INTENDED ALTERATIONS IN THE INTERIOR

Westminster Abbey.

A CLERGYMAN OF THE CHURCH OF ENGLAND.

1844.

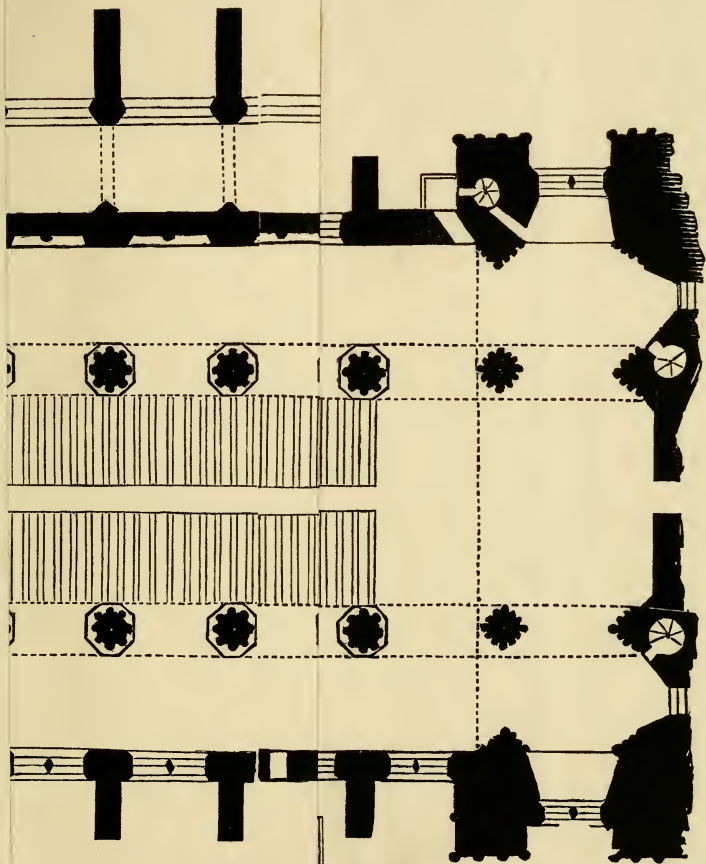
The friend to whose kindness I am indebted for the Plan, has drawn the stalls *in front* of the piers, instead of *between* them, as suggested in p. 12.

2. Those in the transepts, who are at all removed from the line of the present choir, will be quite unable to see the clergyman, either during the prayers, the lessons, or the communion service. A glance at the annexed plan will at once show this, and make it evident that a person standing at all far back in the transepts, will be quite unable to obtain a view of the place (near the second pier from the transept) whence the prayers and lessons are now read, or of the altar. Now without attaching undue importance to the congregation seeing the officiating minister, still it cannot be denied that the being within sight of the clergyman tends to fix the attention to the prayers which he says, or the Scripture which he reads; and,

admitted to the services of the Church. To effect this, I venture to suggest that the present screen at the west-end of the choir should be removed, that the organ should be placed (as at Winchester) on the north side of the church, that the stalls should be carried more towards the east, and that the whole space of the nave, extending from the tower or cross of the transepts to the west door, should be fitted with open seats for the accommodation of worshippers. I think no one will doubt that if this plan be feasible (as I hope to show it is), it will render the appearance of the church yet more majestic and beautiful than it is at present: it is, indeed, impossible to fully realize the grandeur of the *coup d'œil* from the nave to the altar, or the exquisite beauty of the long line of pillars and aisles that would then be disclosed, unbroken by the organ, or the present screen and heavy wood-work which sustains it.

It has been ascertained by experiment, that if the stalls extended only from the present eastern piers of the tower and transept cross to the western piers of the same, there would be ample room for thirteen stalls, thereby providing accommodation for seven clergy² on each side, besides six stalls for lay-singers

on each side, as at present. If the line of the stalls were carried from centre to centre of the piers (as in Henry VII.'s Chapel, and in many cathedrals), the return of the dean and sub-dean's stalls would not be so great as to project to any considerable extent beyond the pier; and if the choir were divided from the nave by a light openwork screen, the view from every part of the church to the altar would be uninterrupted; i. e. every single person present at Divine service would command a view of the clergyman during the whole of the prayers, lessons, communion service, and sermon. In order to effect this, it would be necessary to remove the organ from its present position; and it is suggested, that it might be placed in the arch (B) of the west aisle of the north transept. No objection seems to exist to its being placed there, as the space behind it being open to the transept, no ill effect can be anticipated to the sound of the instrument; and, indeed, it is traditionally stated to have been anciently on the north side of the church of Westminster, as it was generally (in former times) in English churches.

choir, and would therefore be distinctly heard over all the church, and that would assist the attention, and enable the more distant worshippers to follow the clergyman at the altar. And as it is suggested that the pulpit (A) should remain nearly in its present position, which will then be at the junction of the choir and nave, there is no doubt that the preacher would be heard distinctly in every part of the church ; more distinctly, indeed, perhaps, than he is now, surrounded by the wooden screen and stall-work. In fact, it seems impossible quite to estimate the power the voice would have if these obstacles, which now so much hamper it, were removed ; and moreover, as the people would be then more equally spread over the whole church, it is probable that a large congregation would not have the effect of deadening the sound of the voice, as they have at present, when crowded together *en masse* round the officiating clergyman.
